Petition: #311-23  
Public Hearing:  
12/5/23

## PUBLIC HEARING/WORKING SESSION MEMORANDUM

### **PETITION #311-23**

**2202 Commonwealth Avenue**

***Proposed Elevations***

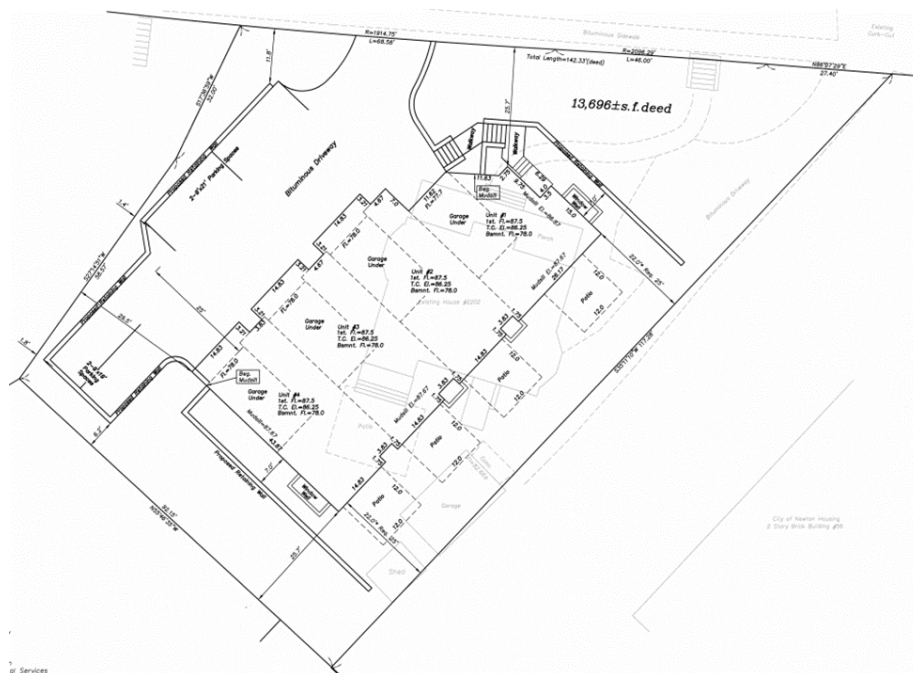
While the proposed structure's height would be four feet higher than the existing structure's conforming 31.3 feet, it is than the maximum 36 feet allowed.
